RADIATION SAFETY & CONTROL SERVICES, INC.

**REVIEW OF THE GROUND WATER
PROTECTION PROGRAM
AT THE FORT CALHOUN NUCLEAR POWER
STATION**

TSD #08-015

Review of the Ground Water Protection Program Fort Calhoun Nuclear Power Station Fort Calhoun, Nebraska

Figure 1

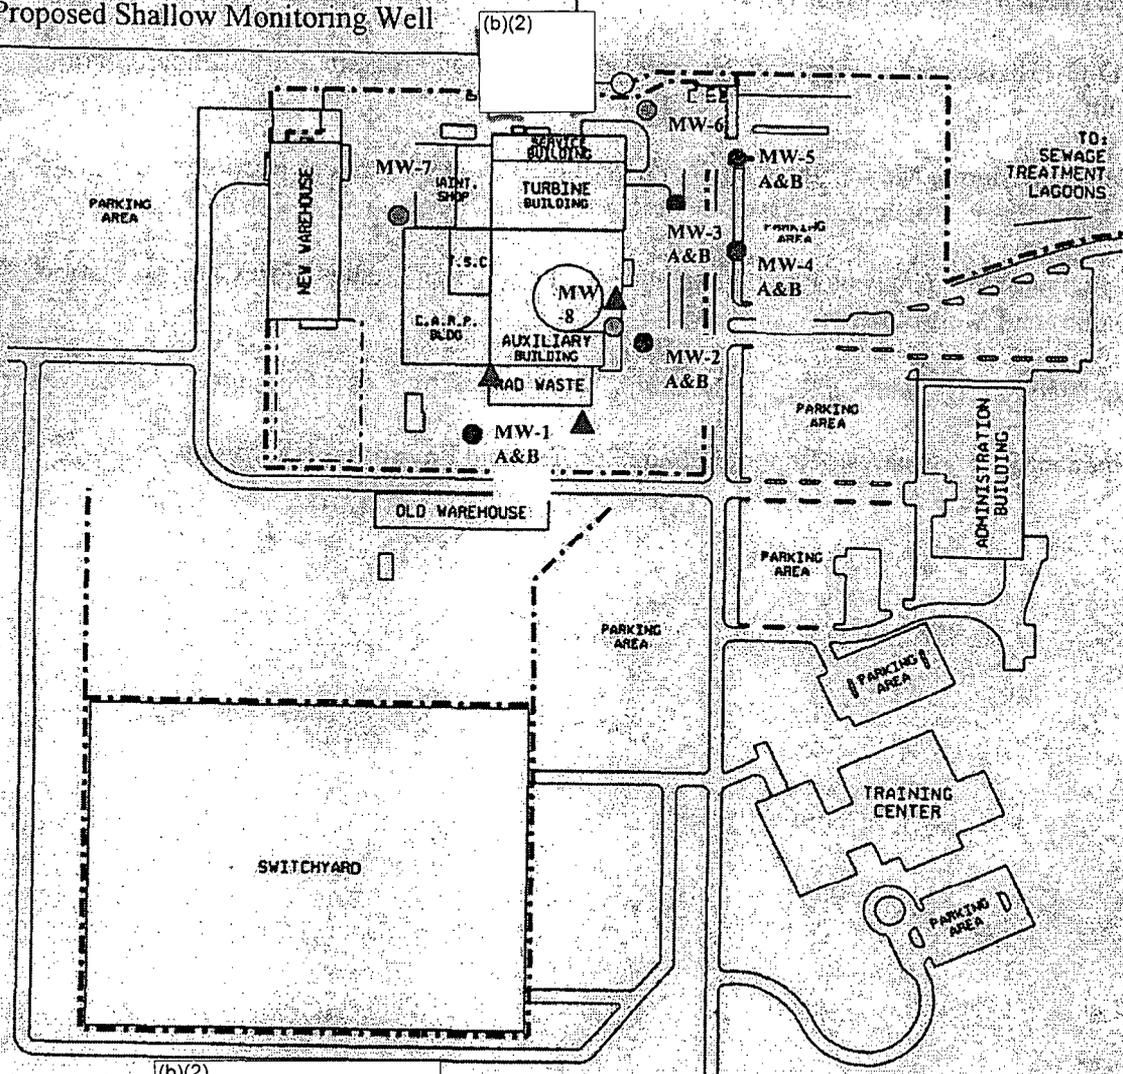
While it appears that potential releases from these sources would be captured by pumping of the RO well, dilution may make it difficult to detect those releases in the RO well discharge. Shallow monitoring wells at two locations near the exterior southwest walls of the radwaste building would provide a means to more easily and precisely detect a release from these potential sources. Figure 1 shows the locations of two shallow monitoring wells proposed on the southwest side of the radwaste building for this purpose.

1. Drill an additional two shallow monitoring wells near the southwest exterior wall of the radwaste building, in locations recent testing has shown are down-gradient of the spent fuel pool and safety injection refueling water tank. These SSCs are potential sources of release to the environment of radioactive liquids. Figure 1 shows the locations of the proposed shallow wells.
